United States Nuclear Regulatory Commission Official Hearing Exhibit	
In the Matter of:	CROW BUTTE RESOURCES, INC. (Marsland Expansion Area)
	ASLBP #: 13-926-01-MLA-BD01
	Docket #: 04008943
	Exhibit #: OST021-00-BD01
	Admitted:
	Rejected: 11/01/2018
	Other:
	Identified: 11/01/2018
	Withdrawn:
	Stricken:

Exhibit Number: OST021

Exhibit Title: Kreamer Powerpoint Slides

Aquifer pump test CW-3

Aquifer pump test CW-3

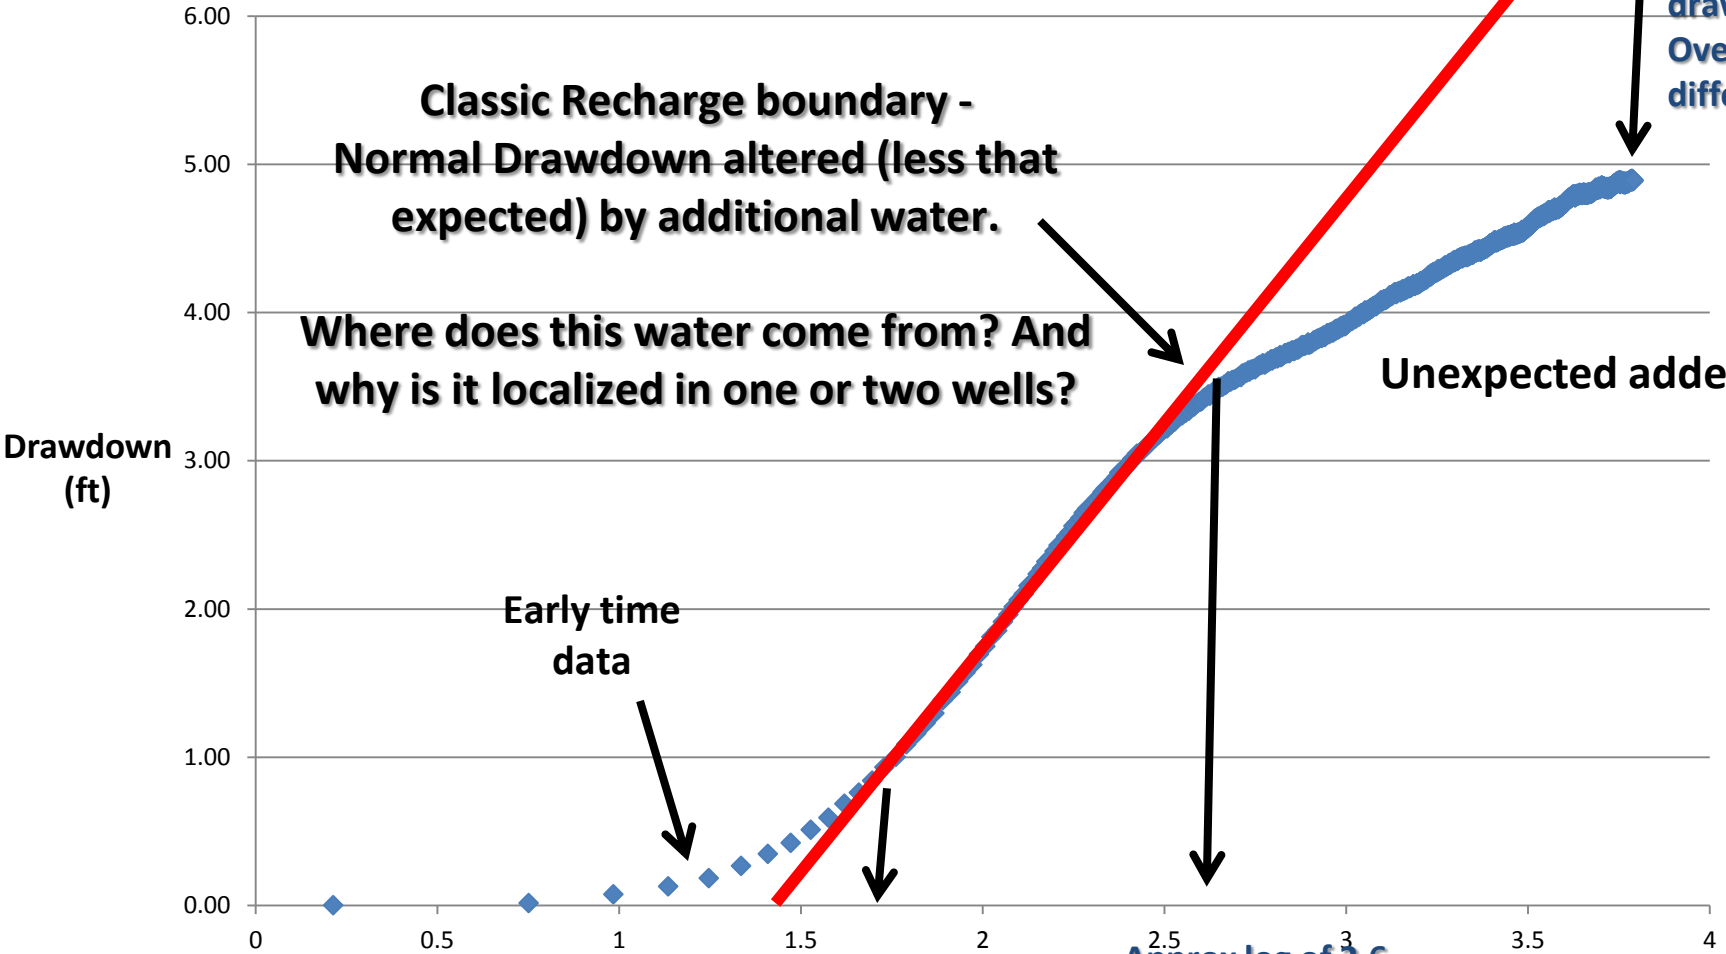
Pumping well 1A is 600ft deep – 150 ft below static water level and casing is 4 inches in diameter with 23 ft of drawdown
water lost from well = Depth $\times \pi r^2 = 23\text{ft} \times \pi (0.33\text{ft})^2 = 7.9 \text{ft}^3 = 59 \text{gals}$
Pumping rate = 27.08 gals/min 2.17 minutes to dewater

Over 2 ft from expected drawdown – Over 30% difference

Classic Recharge boundary - Normal Drawdown altered (less that expected) by additional water.

Where does this water come from? And why is it localized in one or two wells?

Unexpected added water

Early time data

Approx. log 1.77
Approx. 60 minutes

Approx log of 2.6
Approx. 6 hours 20 minutes

Aquifer pump test CW-3

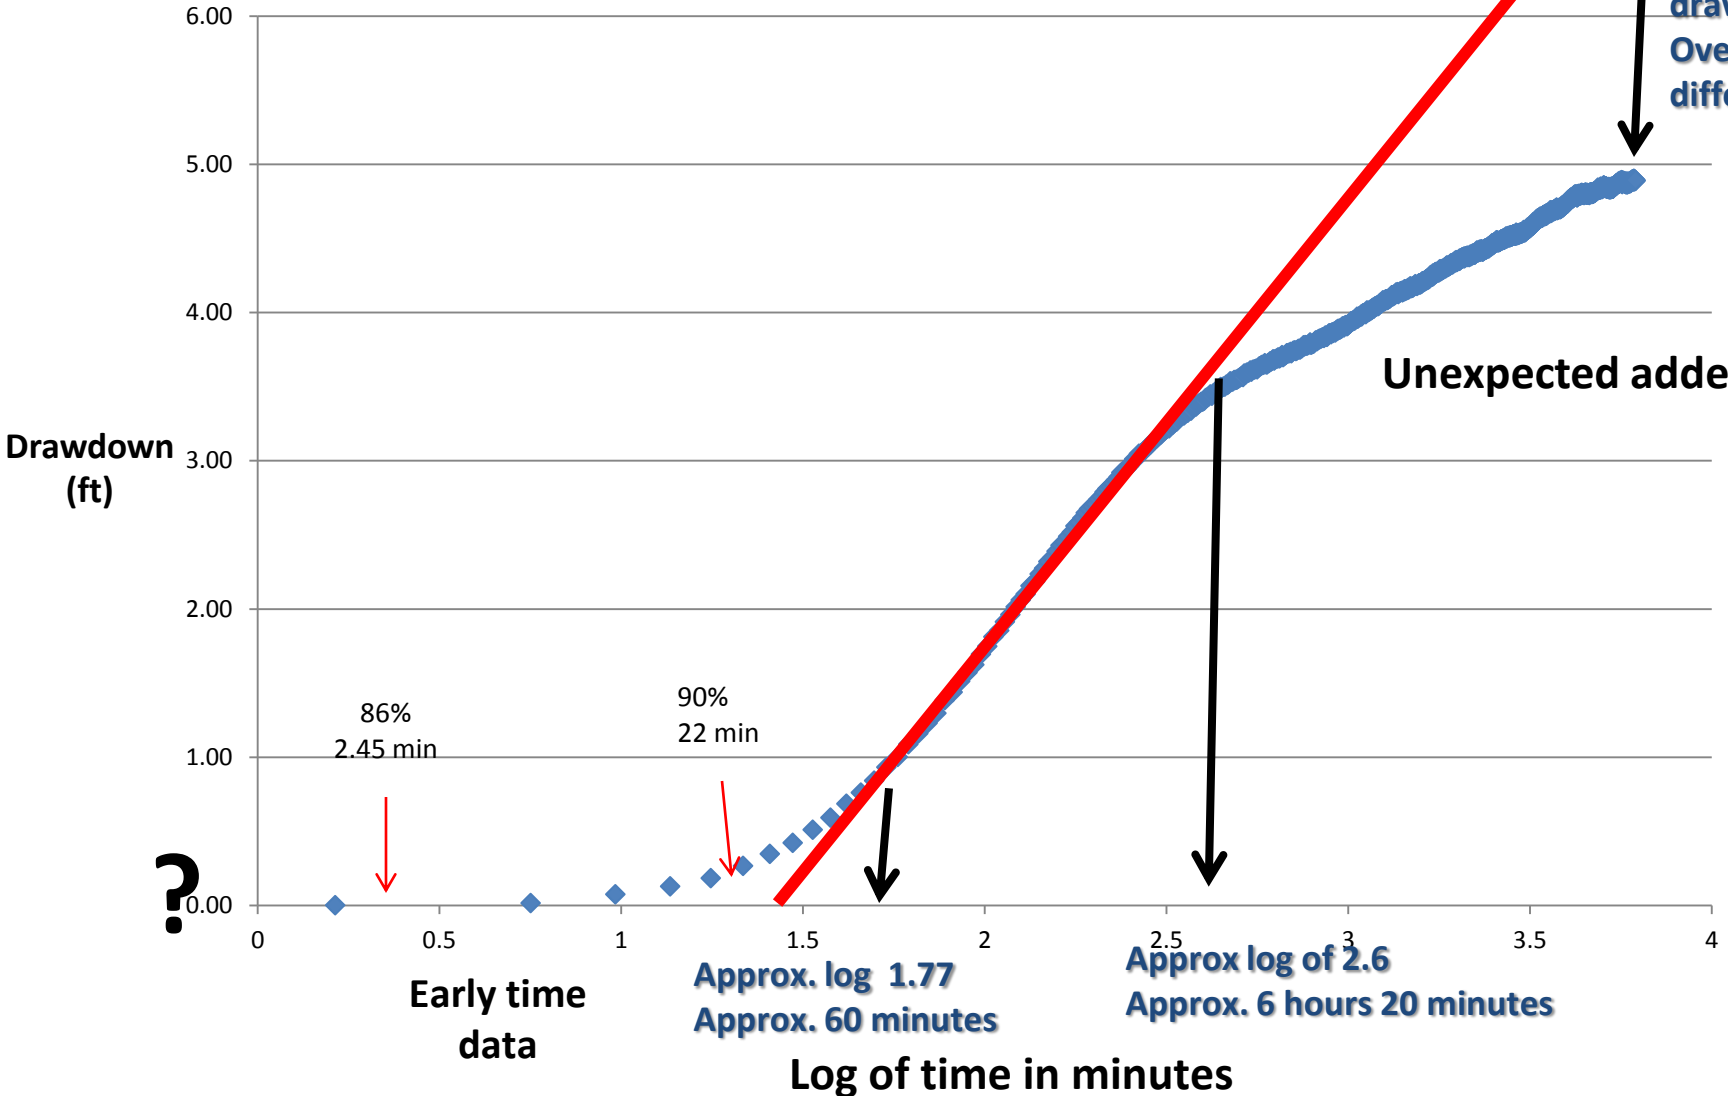
Pumping well 1A is 600ft deep – 150 ft below static water level and casing is 4 inches in diameter with 23 ft of drawdown
 water lost from well = Depth $\times \pi r^2 = 23\text{ft} \times \pi (0.33\text{ft})^2 = 7.9 \text{ft}^3 = 59 \text{gals}$
 Pumping rate = 27.08 gals/min 2.17 minutes to dewater

Over 2 ft from expected drawdown – Over 30% difference

Unexpected added water

Aquifer pump test CW-3

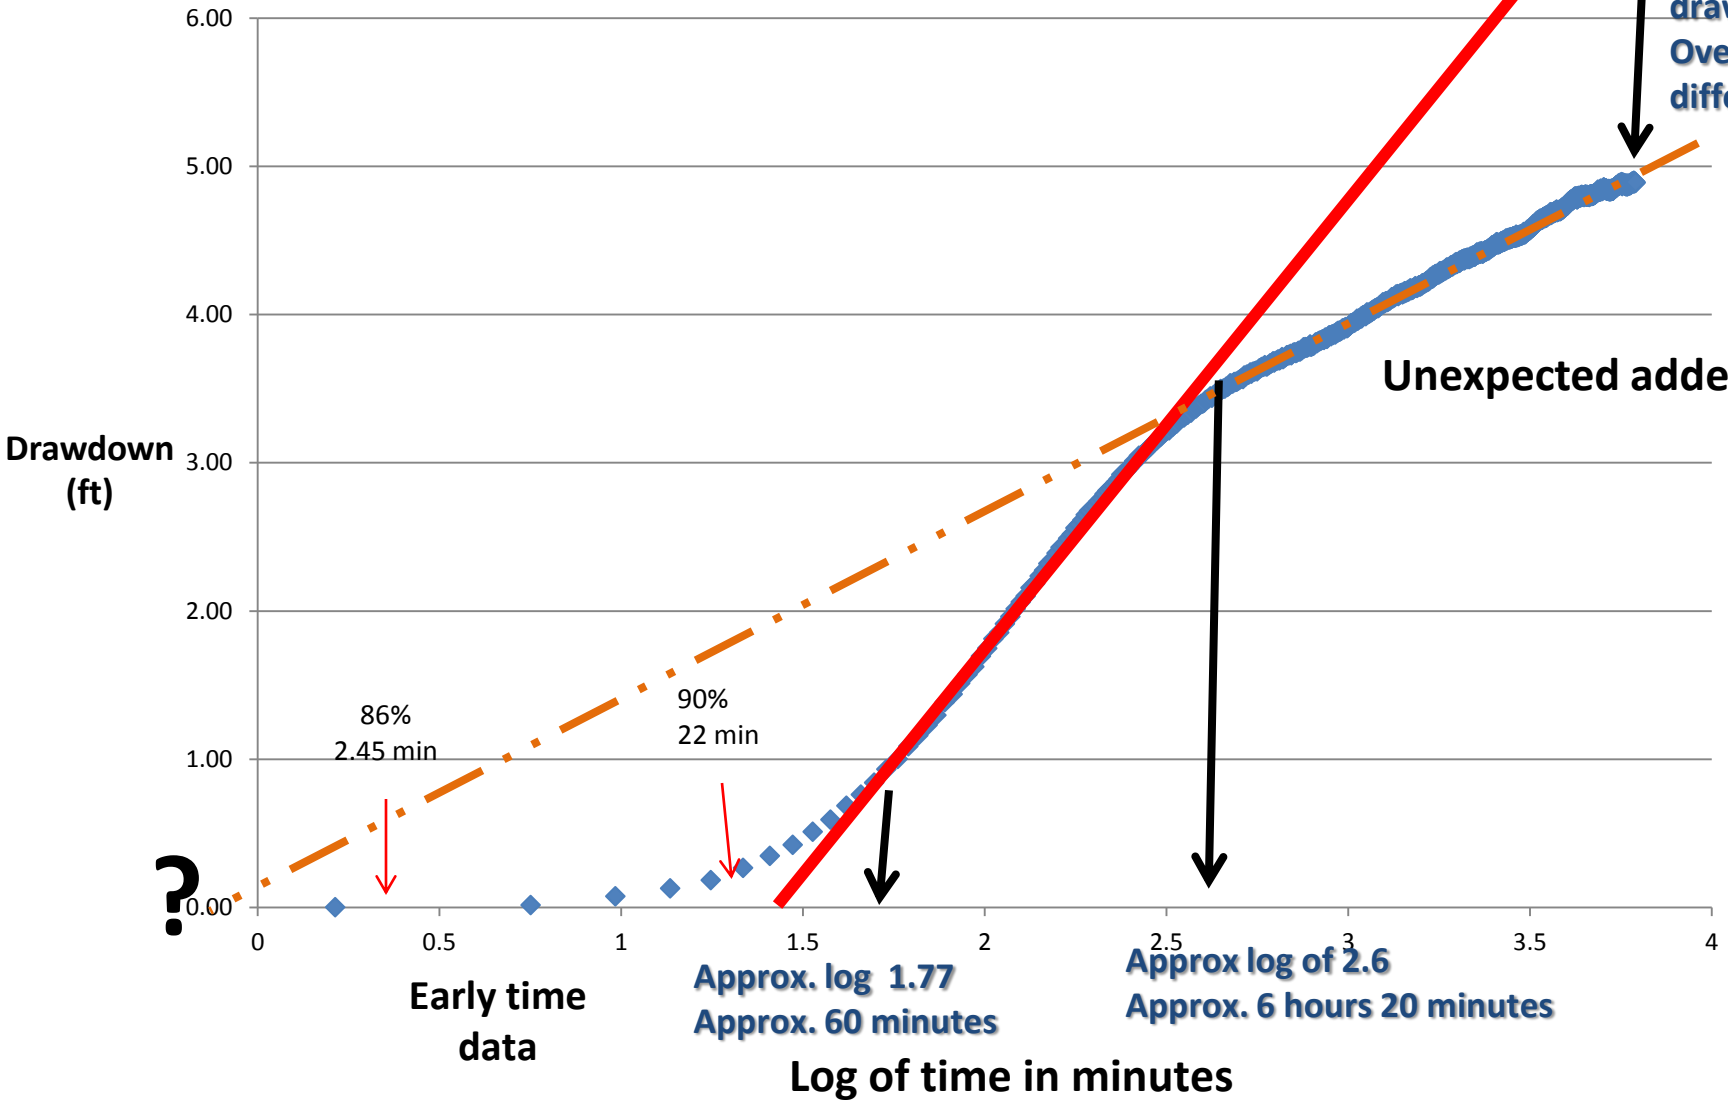
Pumping well 1A is 600ft deep – 150 ft below static water level and casing is 4 inches in diameter with 23 ft of drawdown
 water lost from well = Depth $\times \pi r^2 = 23\text{ft} \times \pi (0.33\text{ft})^2 = 7.9 \text{ft}^3 = 59 \text{gals}$
 Pumping rate = 27.08 gals/min 2.17 minutes to dewater

Over 2 ft from expected drawdown – Over 30% difference

Unexpected added water

Aquifer pump test CW-3

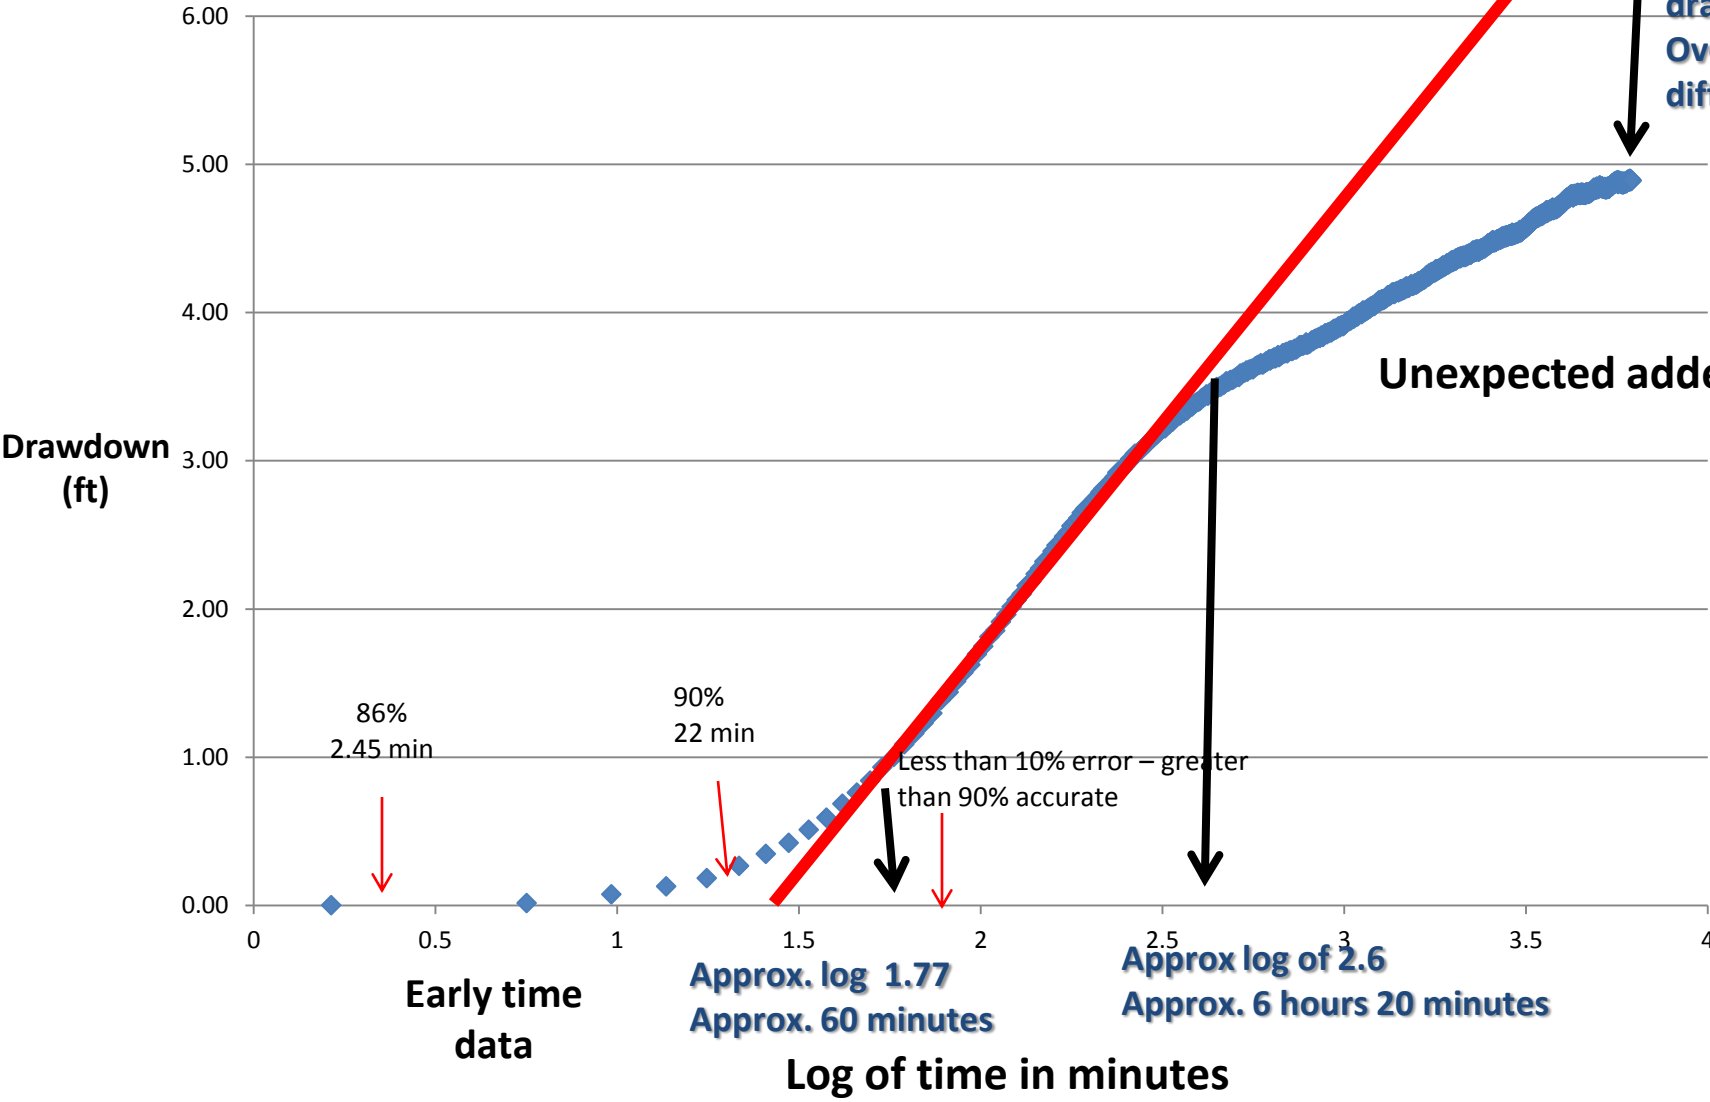
Pumping well 1A is 600ft deep – 150 ft below static water level and casing is 4 inches in diameter with 23 ft of drawdown
 water lost from well = $\text{Depth} \times \pi r^2 = 23\text{ft} \times \pi (0.33\text{ft})^2 = 7.9 \text{ ft}^3 = 59 \text{ gals}$
 Pumping rate = 27.08 gals/min 2.17 minutes to dewater

Within 1000ft of CW 3

- Top of underlying Pierre shale varies more than 40ft in elevation – Fig. 10
- Top of BCCPF varies more than 80 ft in elevation – Fig. 9
- Thickness of BCCPF varies more than 80 ft – Fig. 11
